TO: Mayor Andre Dickens, City of Atlanta
ATTN TO: Monique Forte, Planner III, City of Atlanta
RE: Development of Regional Impact (DRI) Review
FROM: Mike Alexander, Director, ARC Center for Livable Communities

Name of Proposal: Moreland and Custer DRI 3586

Description: A DRI review of a proposal to construct 260 townhomes, 413 multi-family residential units, and 19,500 SF of retail space on a roughly 32 acre site at the SE corner of Moreland Avenue and Custer Avenue in southeast Atlanta. The project site is currently developed as a large strip mall with an extensive surface parking area.

PROJECT	MORELAND & CUSTER 1296 MORELAND AVENUE SE ATLANTA, GA 30316 LAND LOT 113, 15TH DISTRICT	
GSWCC CERT. (LEVEL II)		00000062135
DRAWN BY		HED
DESIGNED BY		MCP
REVIEWED BY		BWS
DATE		04/21/2022
PROJECT NO.		015002008
TITLE		
DRI SITE		
PLAN		
SHEET NUMBER		
C0-20

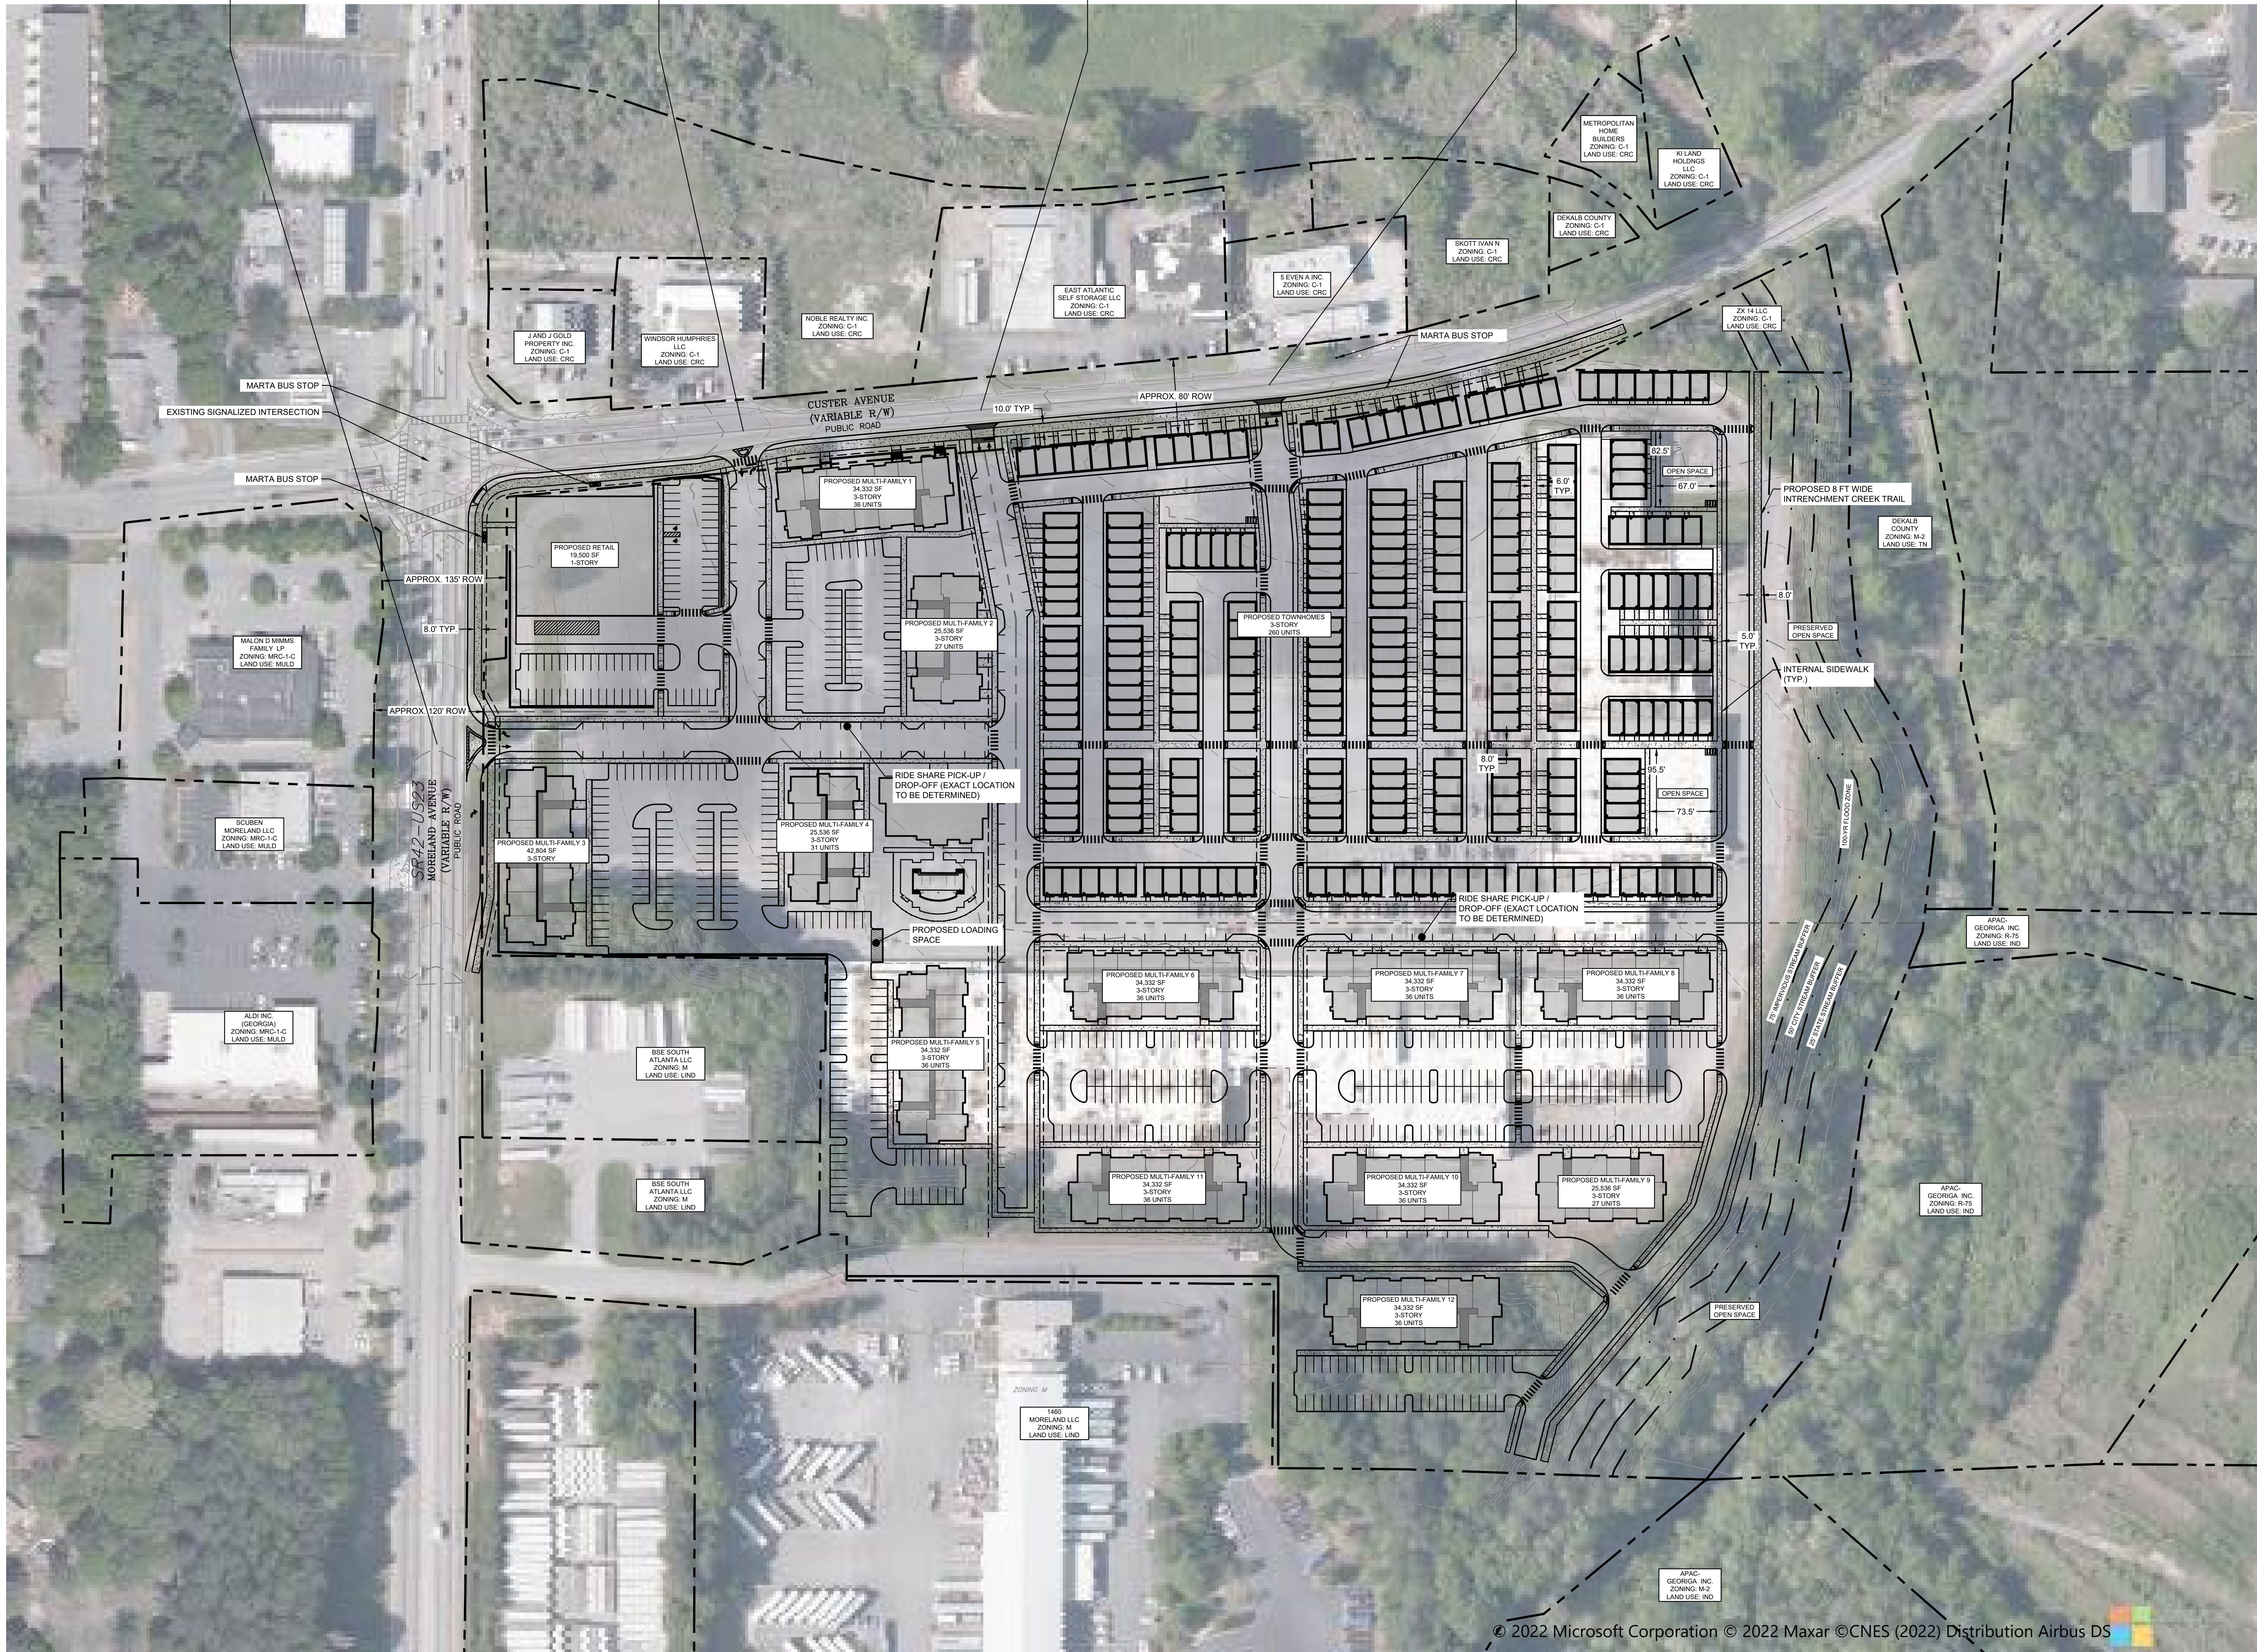
The proposed three driveways along Custer Avenue conflict with the proposed South River Trail segment along the northern frontage.

The street grid misses the key opportunity to create principal north-south and east-west axes for both connectivity and placemaking purposes. A central east-west axis from the entrance on Moreland and terminating with an overlook at the Creek and possibly flanked by small pocket parks would help establish a much stronger sense of place and provide better connectivity.

The two proposed small green spaces on the eastern edge are positive design elements but there is unmet need for green space closer or adjacent to the multi-family buildings and as a potential placemaking element off of Custer or Moreland.

The proposed one-story retail building at the corner of Moreland and Custer will service users outside of the site but is unlikely to be a walking destination for project residents. The LCI contemplated a much taller mixed use building to establish an urban presence at this key corner; a one-story building will not accomplish this or be differentiated from the prevailing existing one-story retail strip condition along Moreland. A central purposed of the LCI was to move beyond this auto-oriented development pattern, especially at key nodes that is also not supportive of walkability and pedestrian safety goals. Ideally this key corner location would host at a minimum another three-story multi-family building with ground floor retail that would extend along Moreland to the driveway entrance.

The proposed plan appears to show stub-outs at the southern ends of the north-south roads on the east and west sides of the site which will provide future connectivity to the parcels to the south when they are eventually redeveloped.

A deceleration lane proposed for driveway A on Moreland Avenue would diminish the pedestrian experience and safety and is not in keeping with the walkability vision for the site.

The three site driveways proposed for the Custer Avenue frontage conflict with the goal of providing a safe enhanced pedestrian route in the form of the South River Trail segment included in the design; a reduction to two driveways would significantly limit this conflict.

A total of 1,197 surface parking spaces are proposed. No EV charging or bicycle parking spaces appear to be proposed; inclusion of optimal numbers of both would be supportive of regional EV infrastructure development and multi-modal transportation goals.
